Staff
Summary
Report

SUBJECT: SALT RIVER PROJECT CREDIT UNION #SPD-99.16

BRIEF: This is the second public hearing for Salt River Project Credit Union for an Amended Preliminary Planned Area Development for Papago Park Center and a Final Planned Area Development for Parcel F-1 at 1511 North Project Drive.

SPD-99.16

CONCEPTUAL SITE PLAN

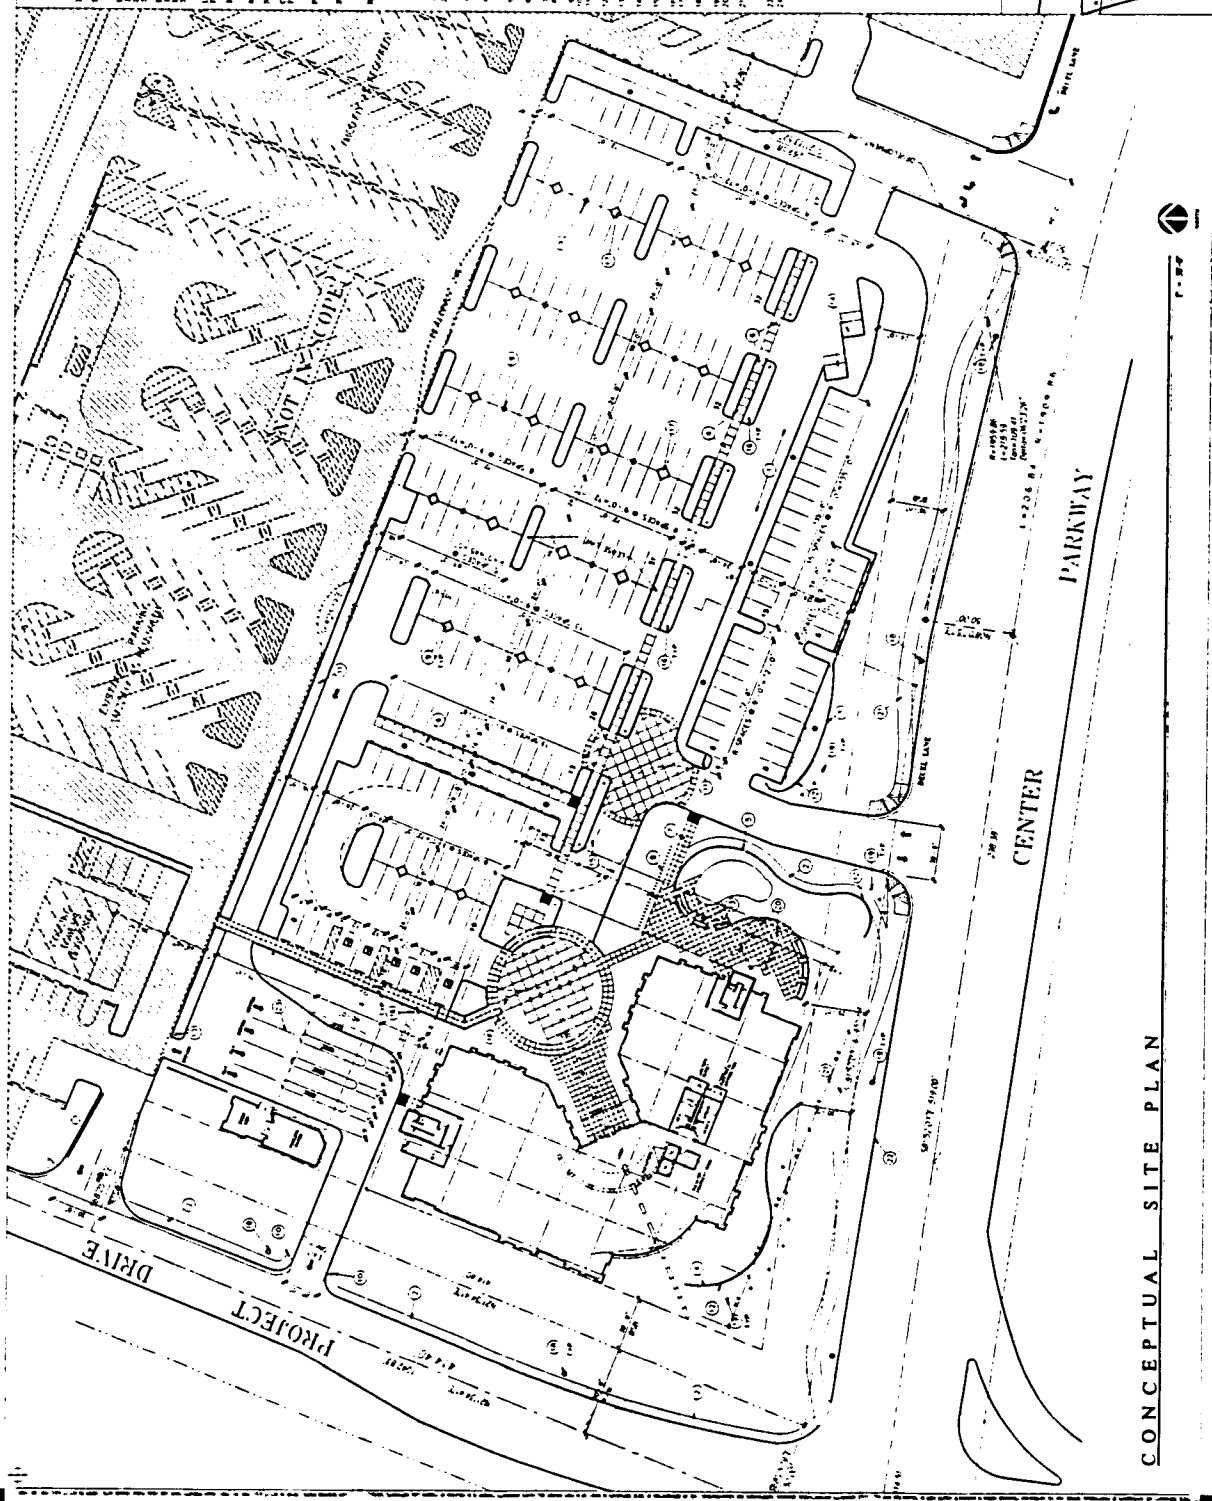
Two-way access would occur from Center Parkway Drive to the site. However, the driveway on Project Drive would be one-way, for exit-only traffic. The purpose of this was to resolve the issue of using a left turn into the site to use ATM teller machines located near Project Drive. On-site circulation and exiting the ATM teller area onto Project Drive, west of the Center Parkway intersection, should mediate any access-conflict issues. Public Works/Transportation staff has been working with the developer on details of the following items: Offsite improvements for the north half of Center Parkway, including future medians, road closure to Van Buren & Old Washington, and a bus shelter requirement. Conditions have been added to require the developer to resolve these issues with Public Works staff.

At its meeting of March 3, 1999 the Design Review Board approved the building elevations, site plan and landscape plan for **PAPAGO PARK CENTER - SRP CREDIT UNION** located at 1511 North Project Drive in the I-1, Light Industrial District and Rio Salado Overlay District subject to the following conditions:

4. Provide upgraded paving materials, such as unit pavers, exposed aggregate, or colored concrete, as accents for all pedestrian sidewalks on the site, for a crosswalk across the parking area to the building, at the main entry to the building, and at all the main drives to the site.

WEST ELEVATION

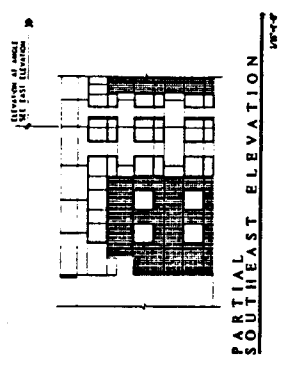
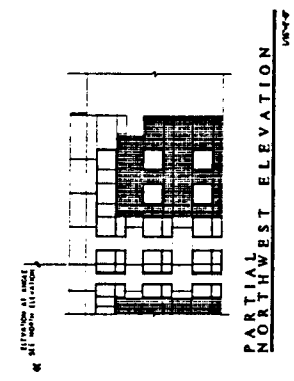
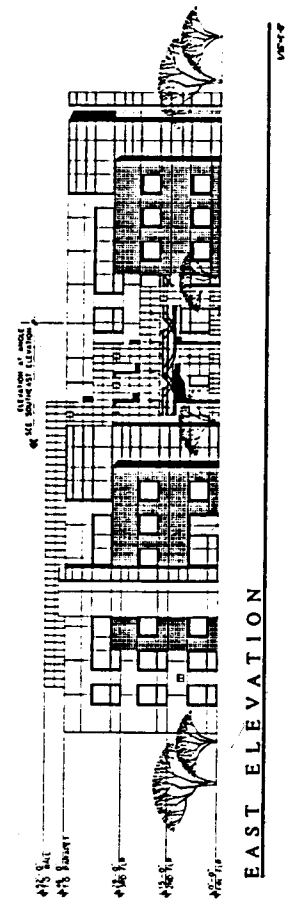
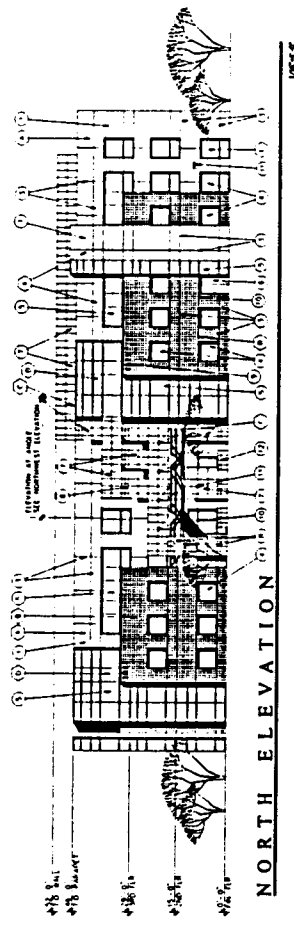
14. Credit Union Building: Provide an additional ½" deep x 2" high reveal on the top portion of all the forty-six (46) foot high concrete panels. The reveal shall line up with the proposed four (4) inch fins located on the adjacent, recessed, glass curtain wall. Details to be approved by staff.
